LEGIONELLA PLUMBING UPGRADES TO BE MADE PART OF AND INCLUDED WITH THE SOLICITATION
AND ANY RESULTANT CONTRACT

BRAND NAME OR EQUAL
LEGIONELLA PLUMBING UPGRADES
SALIENT CHARACTERISTICS

Expansion of the Medical Surgical Clinics Hot Water System

This following upgrades / revisions to the Existing Plumbing Related Specifications and Drawings shall be incorporated into your Bid for the "ROB – Addition" Effort.

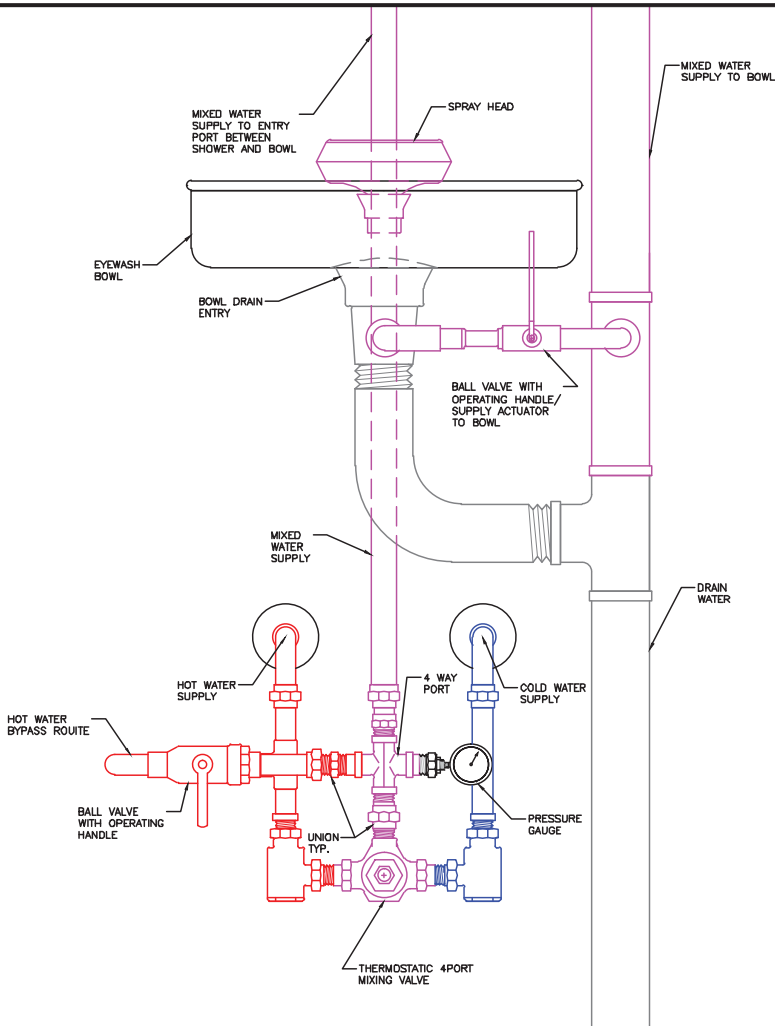
Install eye wash stations where indicated in the Contract Documents.
Stations must be piped as per Attachment C, 'SK7'

1. REFER TO PLUMBING SYSTEMS MANUAL AND SCHEDULE TO COORDINATE SYSTEMS INSTALLATION WITH EACH LOCATION THAT REQUIRES A SPECIALIZED APPLICATION.
2. CONTRACTOR MUST VERIFY ALL FIELD CONDITIONS PRIOR TO WORK START AND AFTER WORK COMPLETION.

626-FCABCP

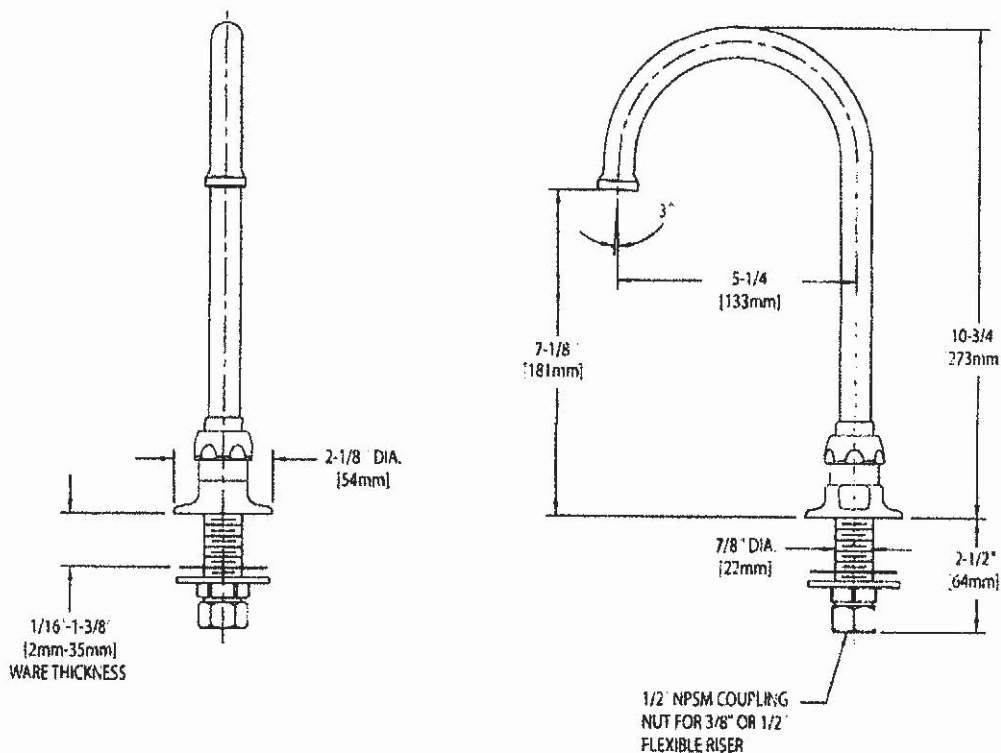
Fixture Systems identified in Attachment 'D', the Chicago Faucet Spout (626-FCABCP) shall be used in place of the Powers model, TYPICAL.
